ADDENDUM NO.03

Bid No. 26-32FAC

**Jurupa Vista Elementary and Ruth O Harris Middle School Exterior Painting
Project No.26-55**

Attachment E – Ruth O. Harris Middle School Reflected Ceiling Plan Exhibit

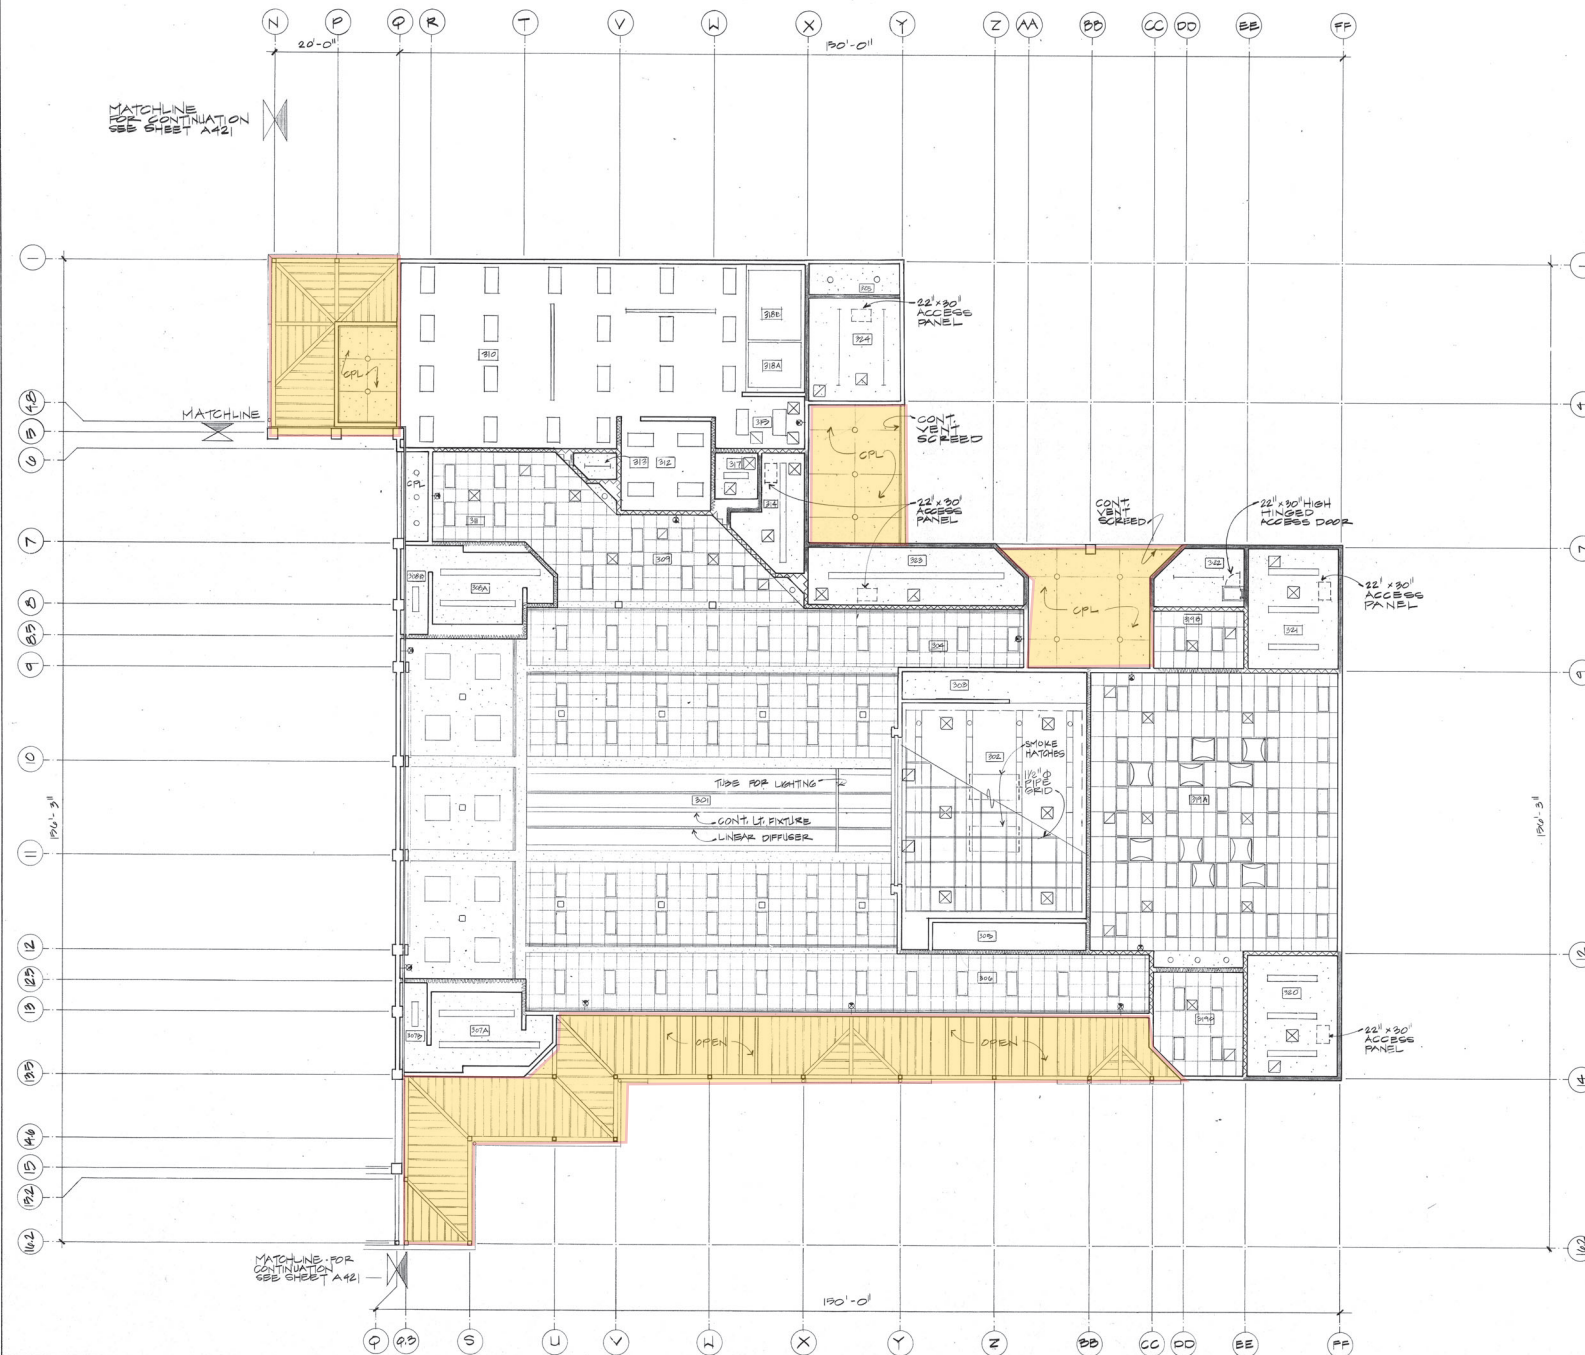
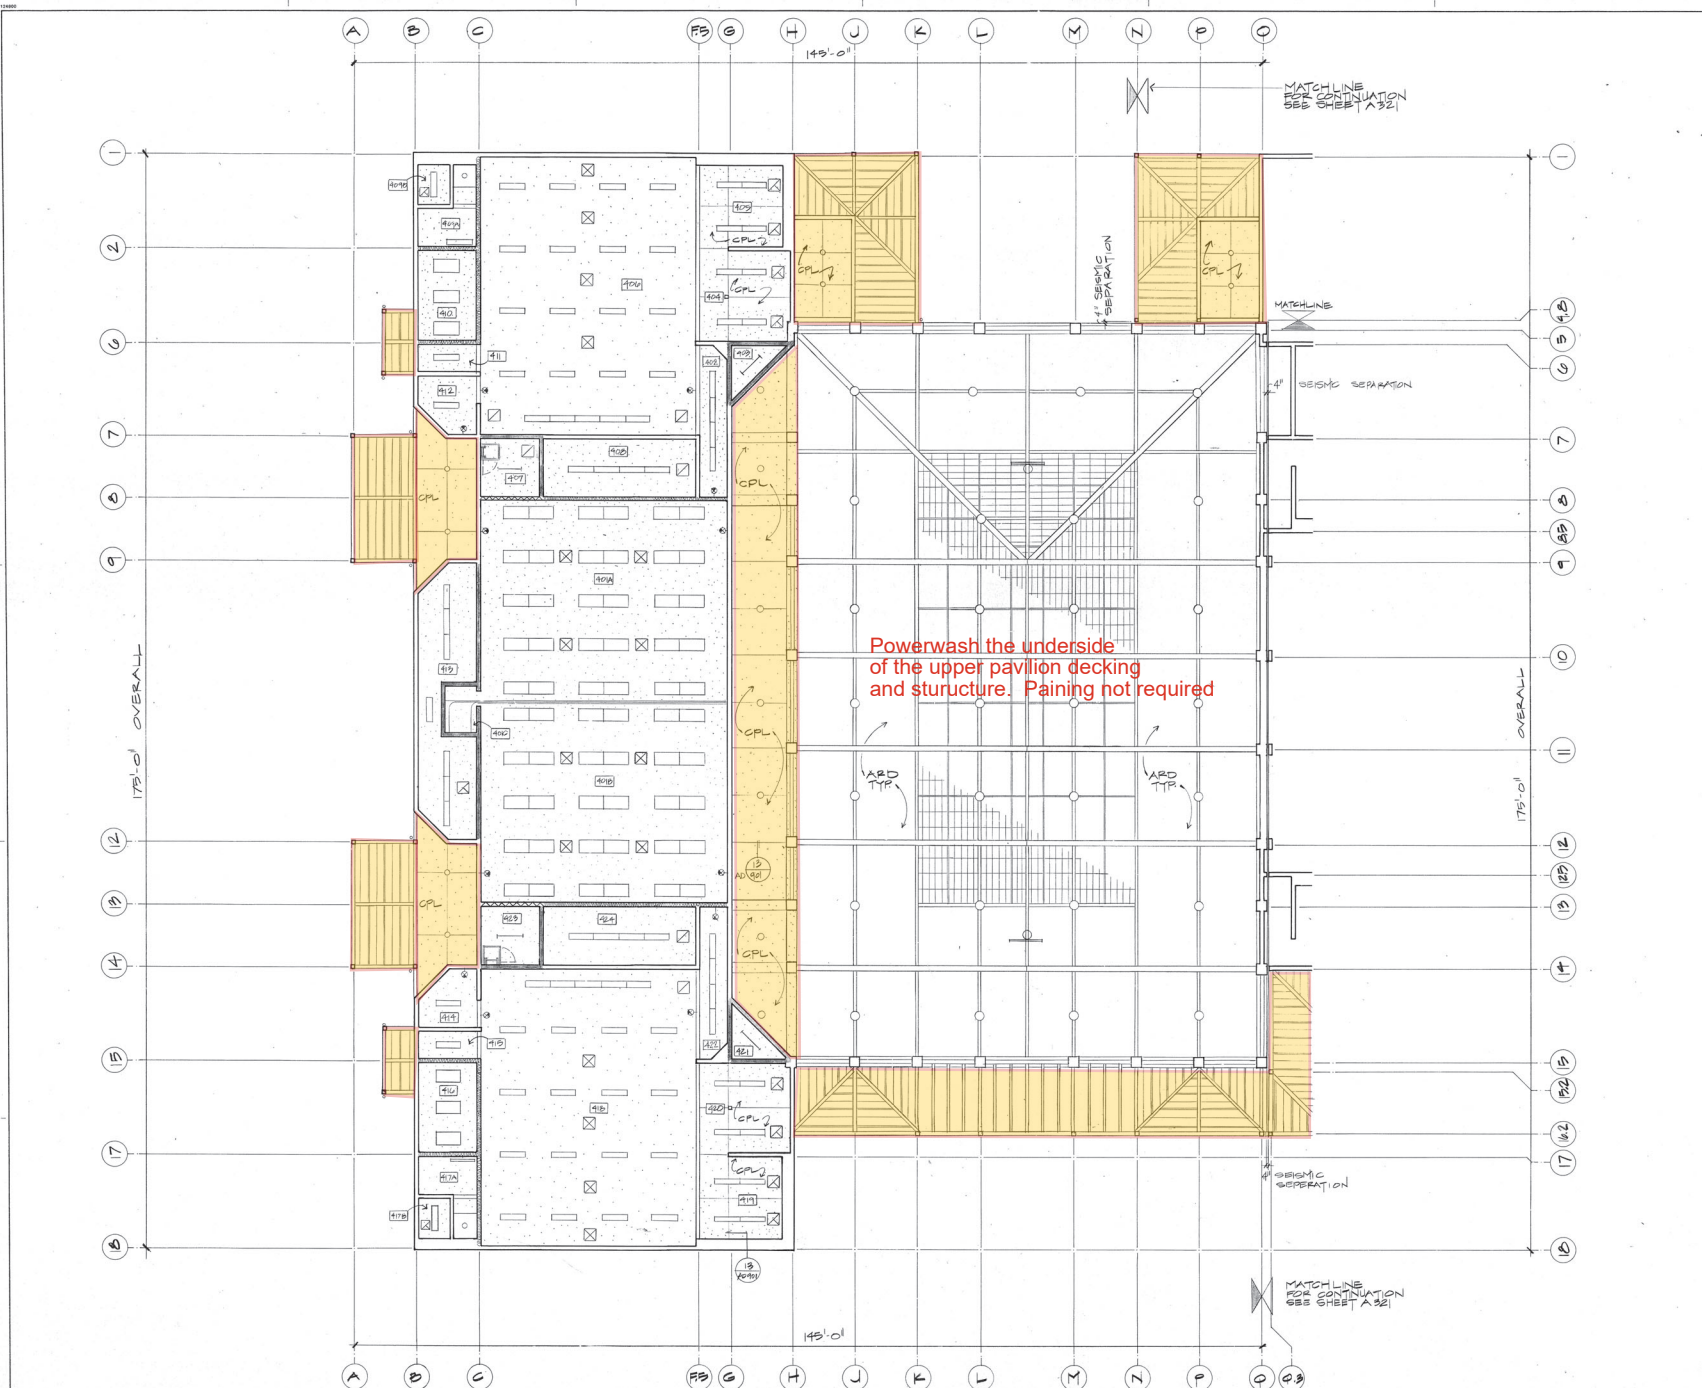
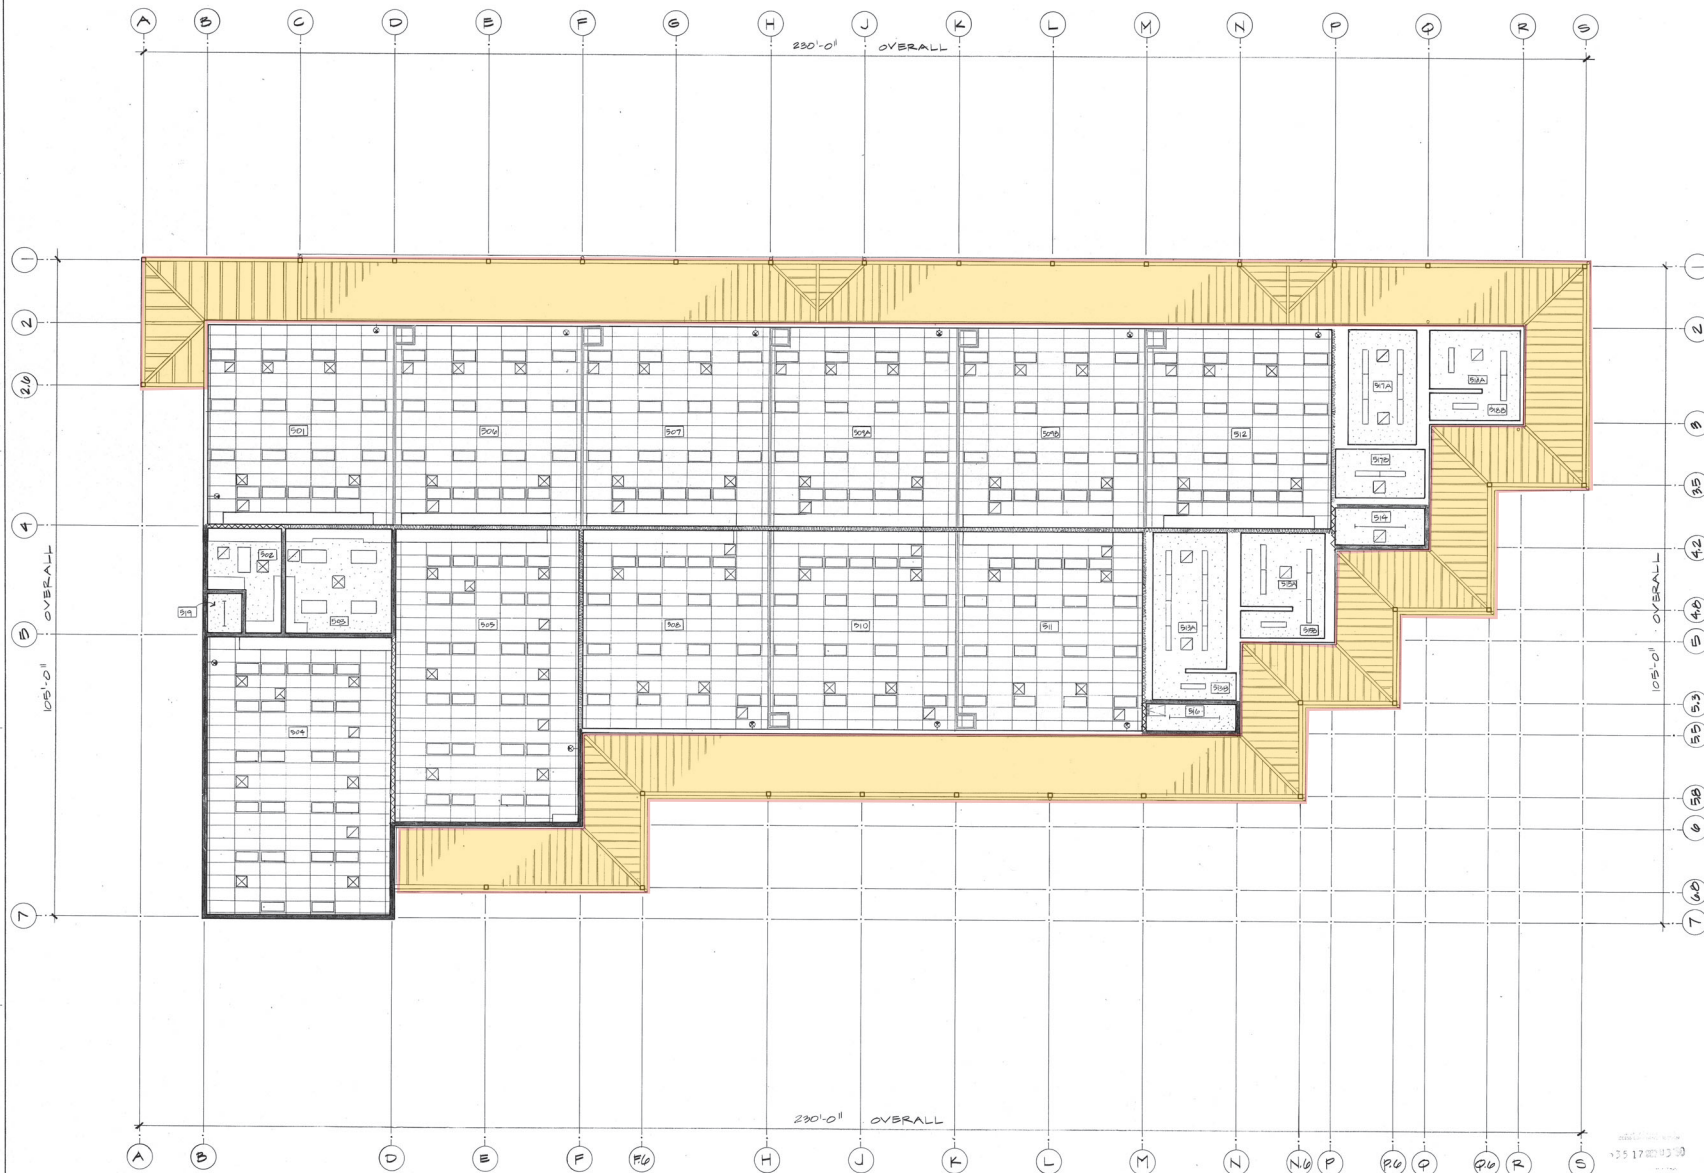
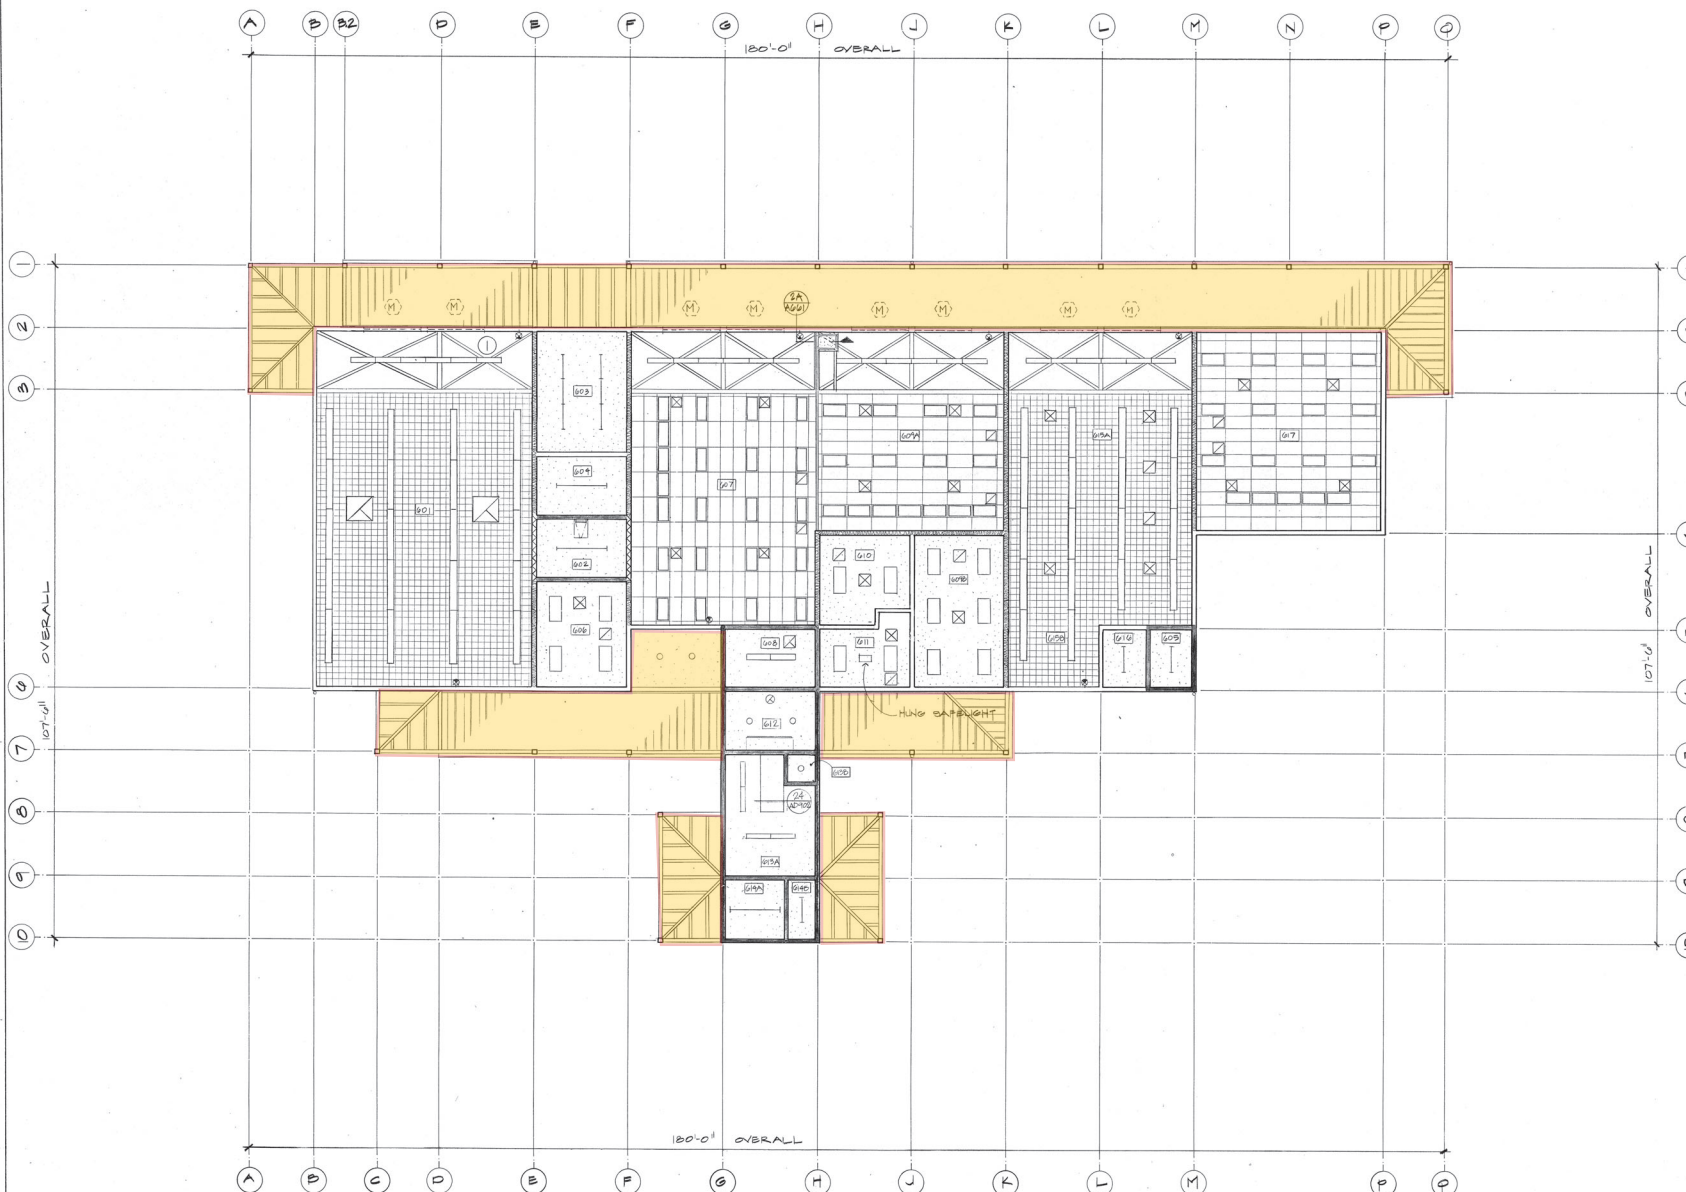
Reflected ceiling plan exhibit added to further clarify ceiling painting areas. All previous addenda responses and scope clarifications remain in effect.

Paint Exposed Metal and Cement Plaster Ceiling, Typical of All Sheets

The painting scope shall include only those roof and ceiling surfaces specifically identified in the renderings, exhibits, and subsequent addenda.

For the Ruth O. Harris Middle School project, visible metal roof surfaces depicted in the renderings as painted shall be painted P2 (DE6370 – Charcoal Smudge), unless otherwise noted.
